Access Compliance Report

Public Rights-of-Way

(Curb Ramps)

Intersection ID: 6739	Main Street: CARRIAGE_OAKS_DR	Cross Street: N/A	Location: W
ADA ID: 7F08830FD109	Ramp Type: Combination1	Initial Pass/Fail: Fail	Overall Compliance: No
			Severity Score: 46.25

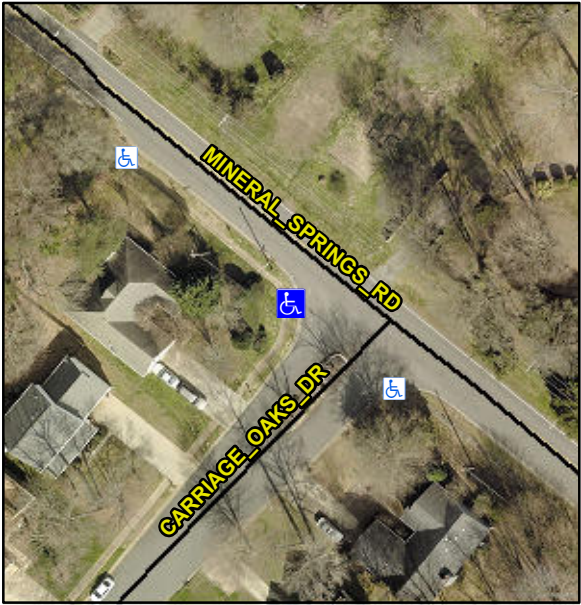
Codes/Mitigation Info/Possible Solution			Field Measurements/Component Compliance		
	Possible Solutions:		Compliance	Description	Data
	Remove & Replace Entire Ramp.		N/A	Ramp Length LT (in)	47.5
			Yes	Ramp Width LT (in)	57.0
			Yes	Ramp Slope LT (%)	2.8
			No	Ramp XSlope LT (%)	5.0
			N/A	Ramp Length (in)	48.0
			Yes	Ramp Width (in)	48.0
			N/A	Flare Type LT	N/A
			N/A	Flare Slope LT (%)	N/A
			N/A	Flare Traversable LT?	N/A
<p>Surveyor Notes:</p> <p>LT RP < 5%</p> <p>PROW/ADA:</p> <p>R304.5.1, R304.2.2, R304.5.3, R304.3.2</p>			N/A	Ramp Slope RT (%)	9.2
			No	Ramp XSlope RT (%)	7.1
			No	Ramp Slope (%)	10.1
			Yes	Ramp XSlope (%)	2.8
			N/A	Flare Type RT	N/A
			N/A	Flare Slope RT (%)	N/A
			N/A	Flare Traversable RT?	N/A
			N/A	DWS Provided?	N/A
			N/A	DWS Contrast?	N/A
			N/A	DWS Length (in)	N/A
<p>Street 1 Name</p> <p>Stop Condition-Street 1</p> <p>Street 2 Name</p> <p>Stop Condition-Street 2</p>			N/A	DWS Full Width?	N/A

N/A	DWS Offset (in)	N/A
			N/A	Gutter Slope (%)	N/A
			N/A	Gutter Lip Ht (in)	N/A
			N/A	Painted X Walk1?	No
				X Walk 1 Direction	To SE
				X Walk 1 Width (in)	N/A
				X Walk 1 Slope (%)	3.2
				X Walk 1 X Slope (%)	4.2
			N/A	Ramp inside XWalk1?	N/A
<p>Total Cost:</p> <p>\$ 1800.00</p>			N/A	Ramp inside XWalk2?	N/A
				Road Slope (%)	N/A
				Road X Slope (%)	N/A
			N/A	Clear Space?	N/A
			N/A	Clear Space to XWalk (in)	N/A
			N/A	Any Obstruction?	N/A
				Obstruction Type	N/A
			N/A	Storm Grate/Utility Hazard?	N/A
				Storm Grate/Utility Type	N/A
			Yes	Surface Condition? (G/P)	Good
				Curb Slope (%)	N/A
